DATE: November 15, 2023
TO: Franklin Planning Board
FROM: Department of Planning and Community Development
RE: 122-138 East Central St
Site Plan - Endorsement

CERTIFICATE OF VOTE
Site Plan Modification
122-138 East Central Street

Site Plan: "Site Plan for 122 and 138 East Central Street"

SITE PLAN
COVER SHEET
122 & 138 EAST CENTRAL STREET
FRANKLIN, MASSACHUSETTS
PREPARED FOR
138 EAST CENTRAL STREET, LLC
37 AND 138 EAST CENTRAL STREET
FRANKLIN, MASSACHUSETTS
JULY 27, 2023
SCALE: 1" = 100'

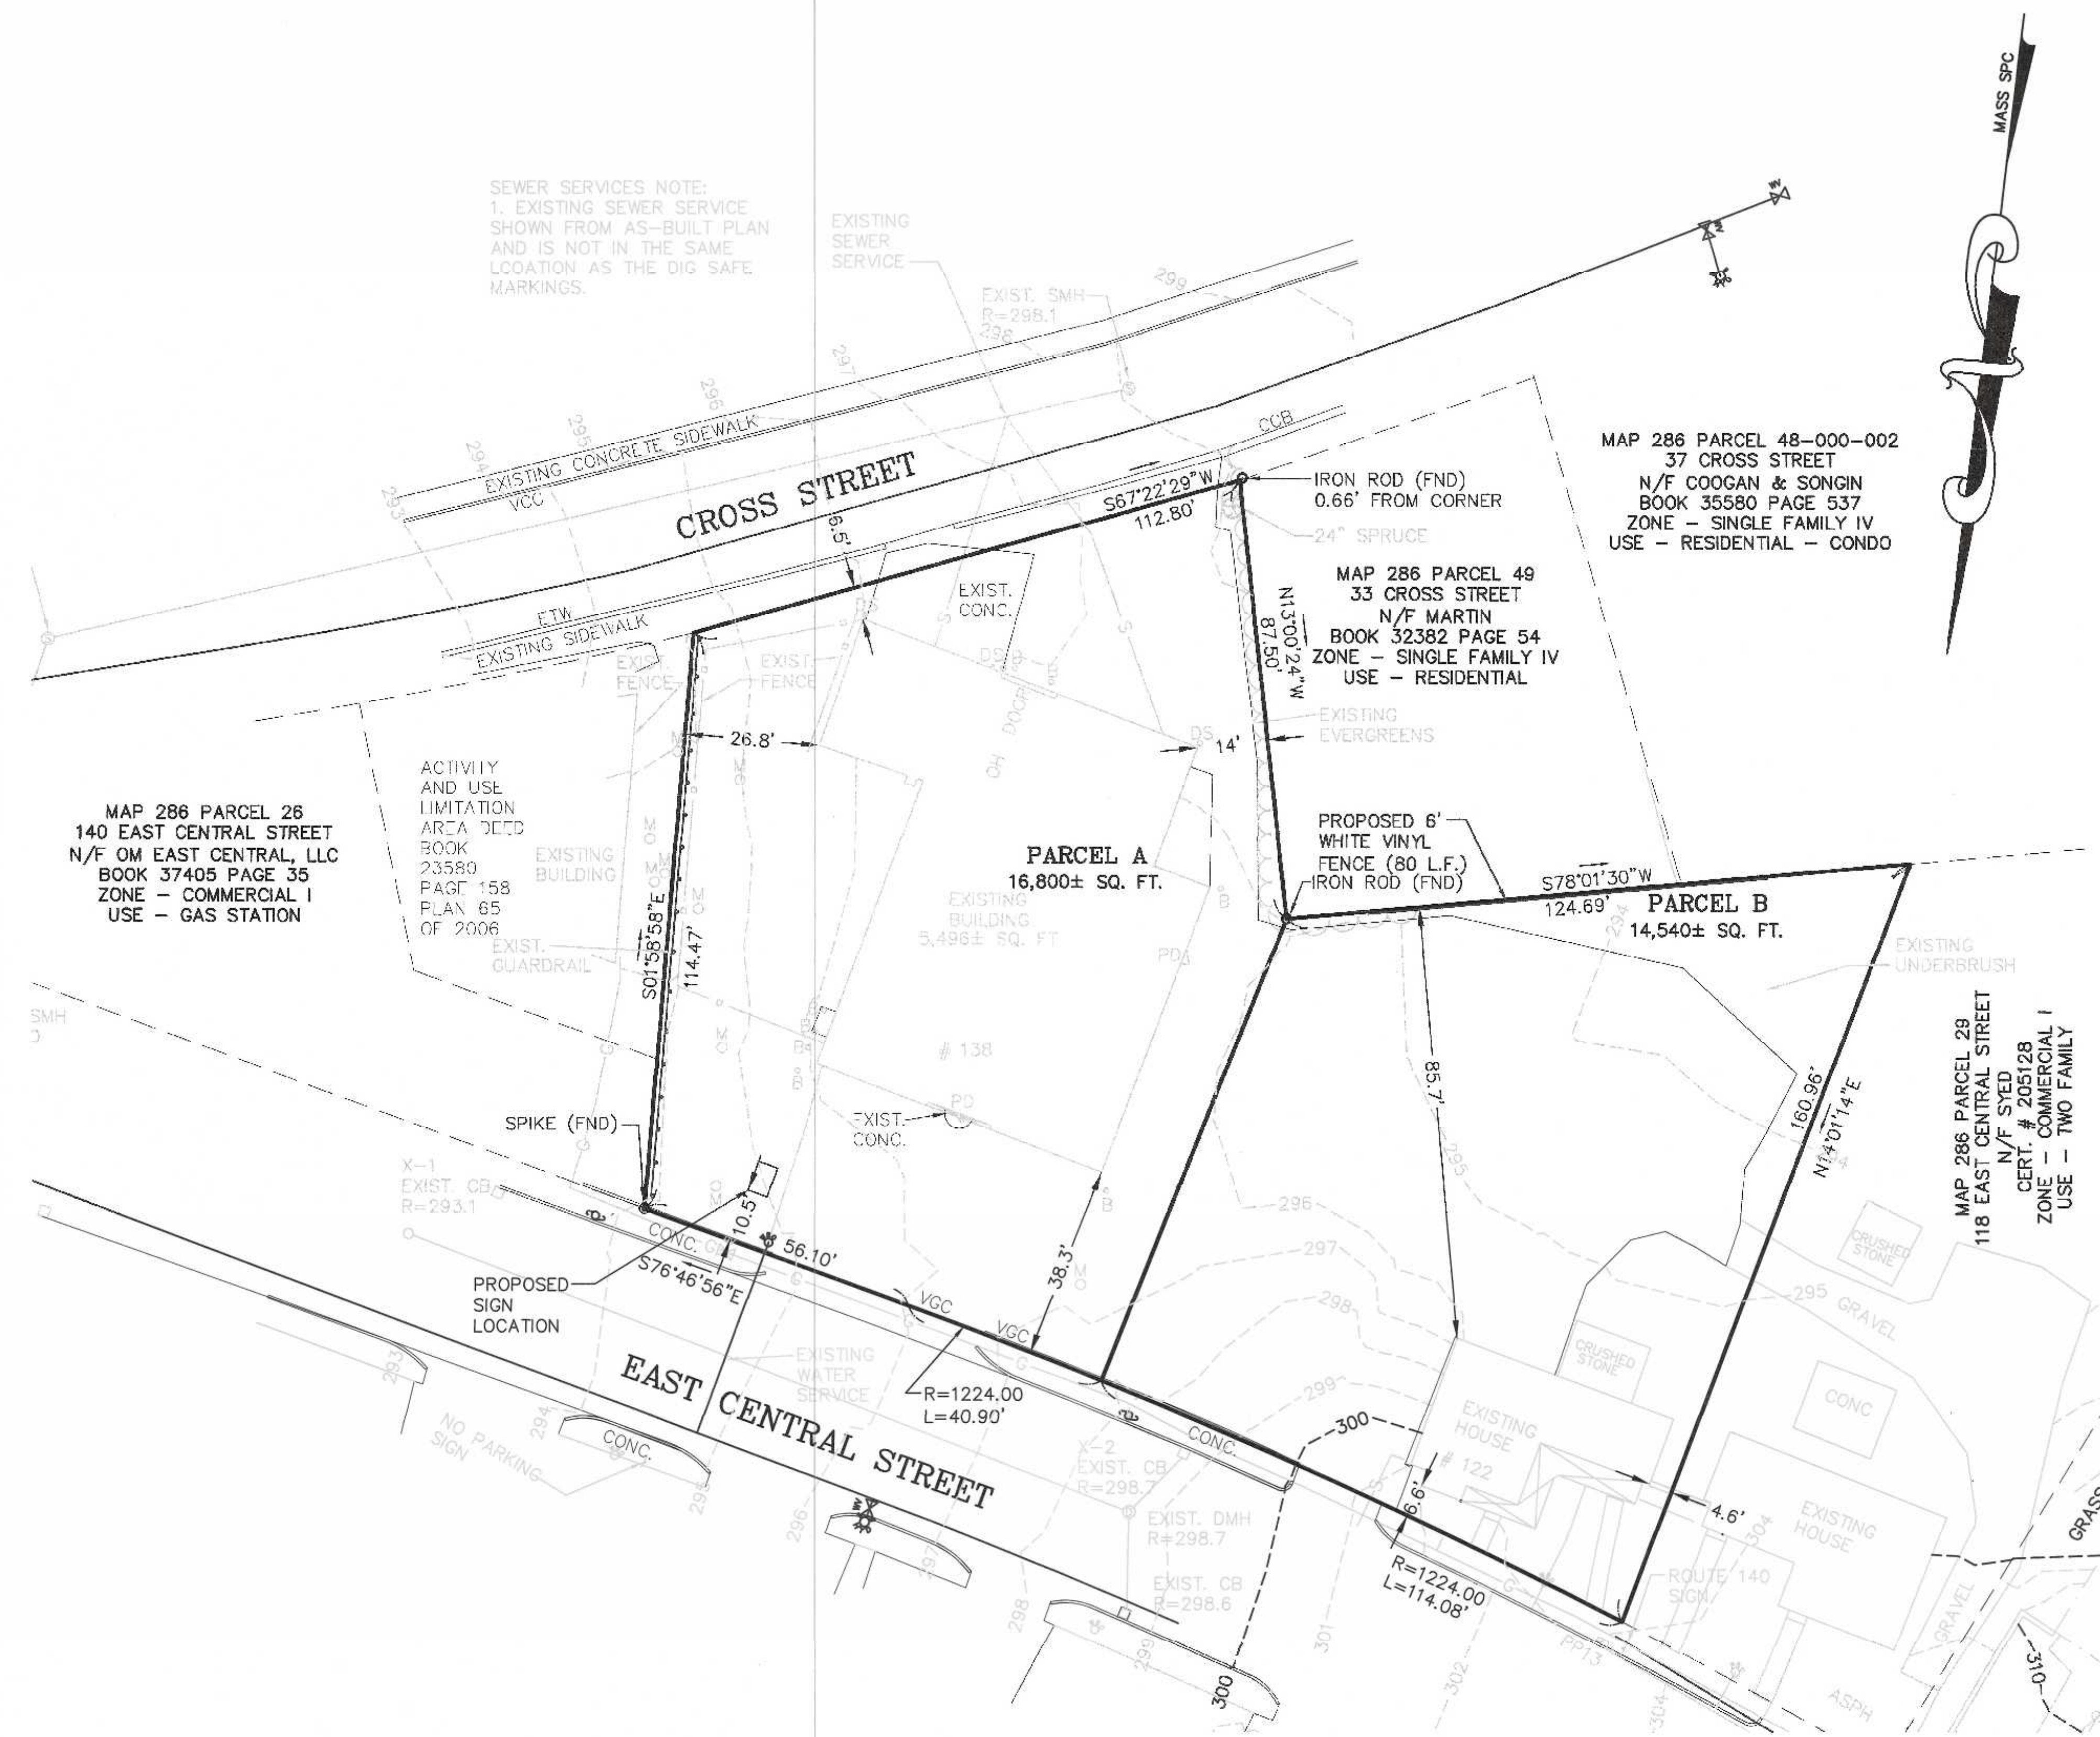
- Prior to the endorsement of the site plan, the following shall be done:
 - The owner/applicant shall provide the entire list of conditions and this Certificate of Vote on the front page of the plans.

- A notation shall be made on the plans that all erosion mitigation measures shall be in place prior to major construction or soil disturbance commencing on the site.

REFERENCE CERTIFICATE OF VOTE AND CONDITIONS OF APPROVAL FOR THE SITE PLAN MODIFICATION 122-138 EAST CENTRAL STREET DATED OCTOBER 24, 2023.

- ALL EROSION CONTROL MITIGATION MEASURES SHALL BE IN PLACE PRIOR TO MAJOR CONSTRUCTION OR SOIL DISTURBANCE COMMENCING ON THE SITE.
